Access Compliance Report

Intersection ID: 18387	Main Street: BURTONWOOD_CR	Cross Street: MONROE_RD	Location: SW
ADA ID: A29B32515086	Ramp Type: PerpDiag	Initial Pass/Fail: Fail	Overall Compliance: No
		Severity Score: 12.5

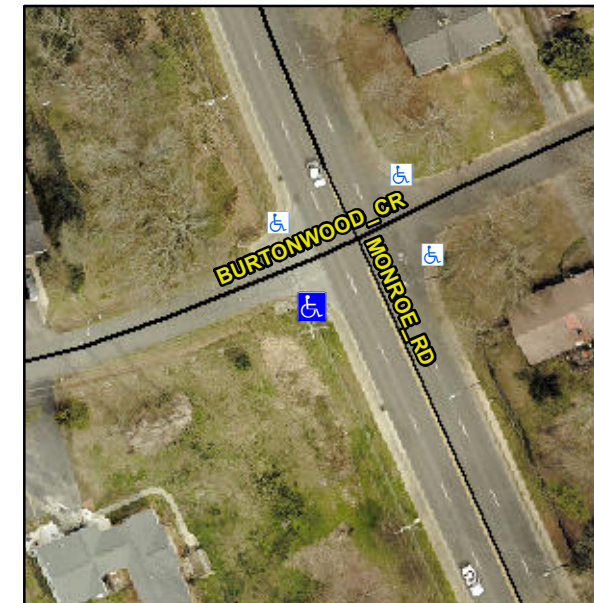
Not Found, R304.2.2

Compliance	Description	Data	Compliance	Description	Data
N/A	Ramp Length (in)	60.0	No	Ramp Slope (%)	9.1
Yes	Ramp Width (in)	48.0	Yes	Ramp XSlope (%)	0.8
N/A	Flare Type LT	N/A	N/A	Flare Type RT	N/A
N/A	Flare Slope LT (%)	N/A	N/A	Flare Slope RT (%)	N/A
N/A	Flare Traversable LT?	N/A	N/A	Flare Traversable RT?	N/A
N/A	Landing Length (in)	N/A	N/A	DWS Provided?	N/A
N/A	Landing Width (in)	N/A	N/A	DWS Contrast?	N/A
N/A	Landing Slope (%)	N/A	N/A	DWS Length (in)	N/A
N/A	Landing X Slope (%)	N/A	N/A	DWS Full Width?	N/A
N/A	Landing Curb? (Y/N)	N/A	N/A	DWS Offset (in)	N/A
N/A	Shared Landing?	N/A			
N/A	Gutter Ponding?	N/A	N/A	Gutter Slope (%)	N/A
N/A	Gutter Lip Ht (in)	N/A	N/A	Gutter X Slope (%)	N/A
N/A	Painted X Walk1?	No	N/A	Painted X Walk2?	No
	X Walk 1 Direction	To E		X Walk 2 Direction	To N
N/A	X Walk 1 Width (in)	N/A	N/A	X Walk 2 Width (in)	N/A
	X Walk 1 Slope (%)	0.3		X Walk 2 Slope (%)	0.7
	X Walk 1 X Slope (%)	4.0		X Walk 2 X Slope (%)	0.2

Remove & Replace Curb Ramp With Two New Directional Ramps or Equivalent.
